CITY OF ALBUQUERQUE

Re: Albuquerque Central Care Center
621 Columbia Dr SE
Traffic Circulation Layout
Engineer's/Architect's Stamp 10-07-2019 (L16D042)

The TCL submittal received 11/21/2019 is approved for Building Permit. A copy of the stamped and signed plan will be needed for each of the building permit plans. Please keep the original to be used for certification of the site for final C.O. for Transportation.

1 SITE PLAN-TCL
1" = 20'-0"

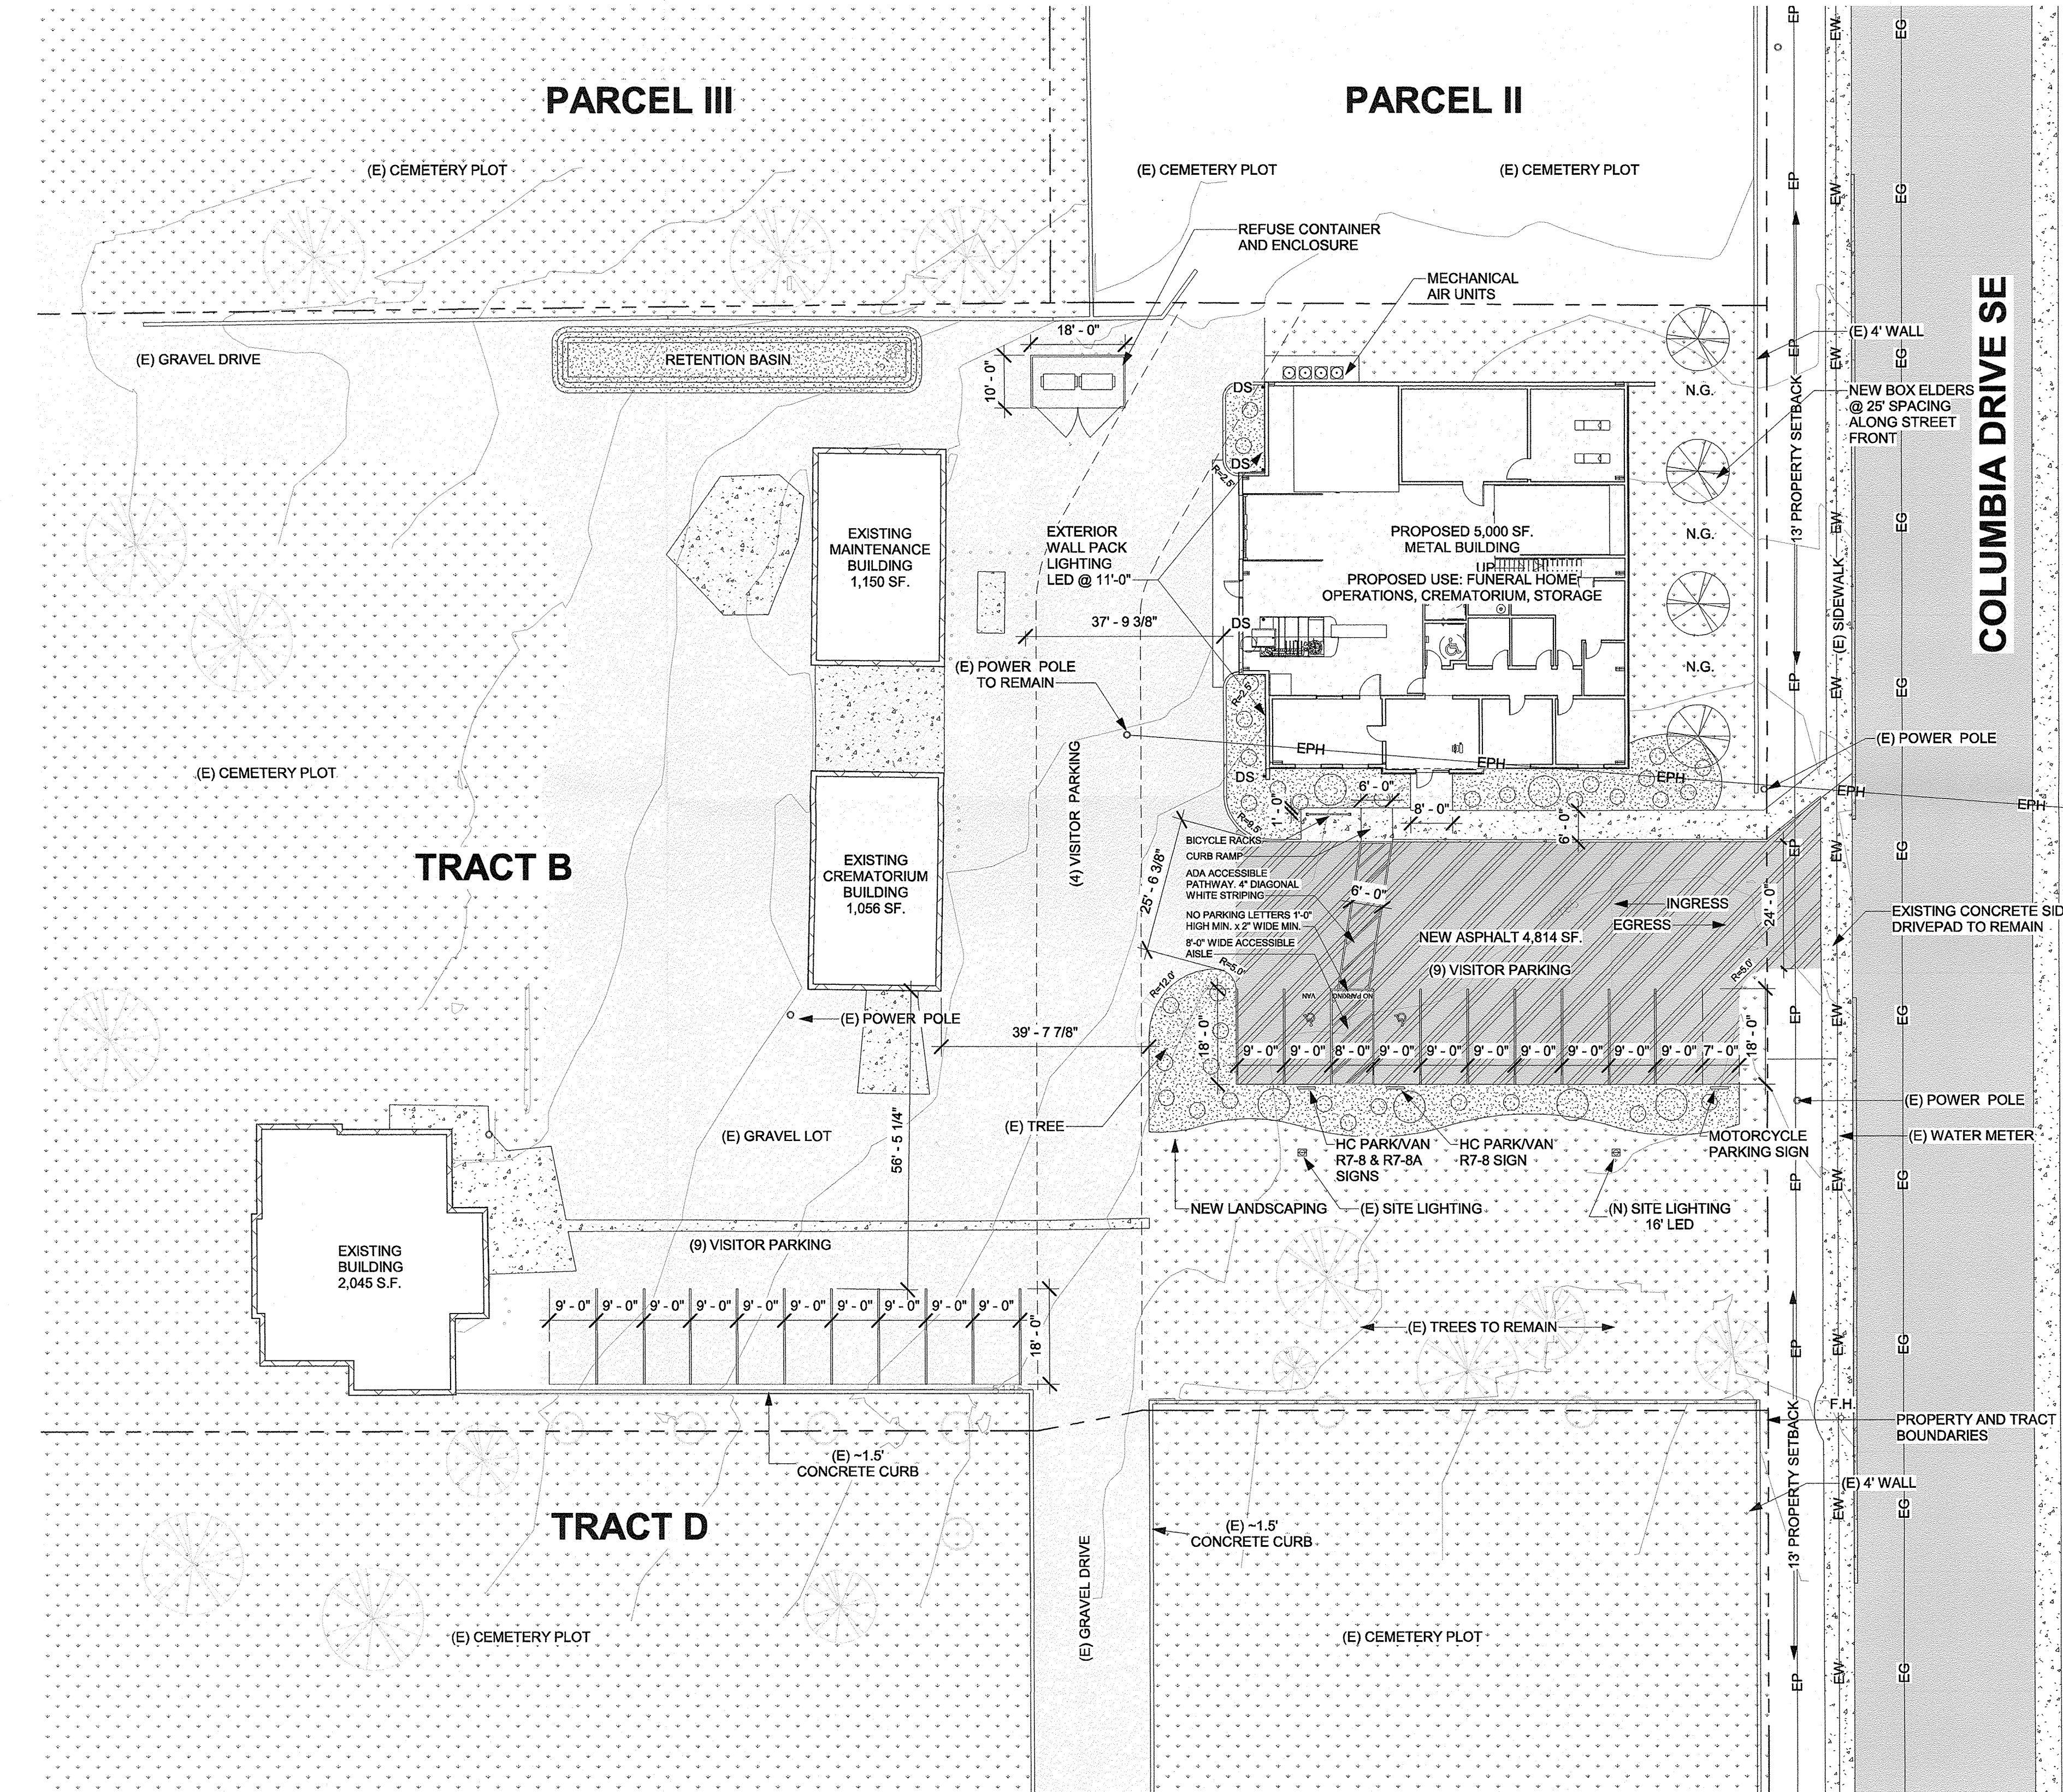
TRAFFIC CIRCULATION LAYOUT
APPROVED
[Signature]
Signed
11-25-19
Date

11/21/19
Solid waste Dept
Access Approved
[Signature]
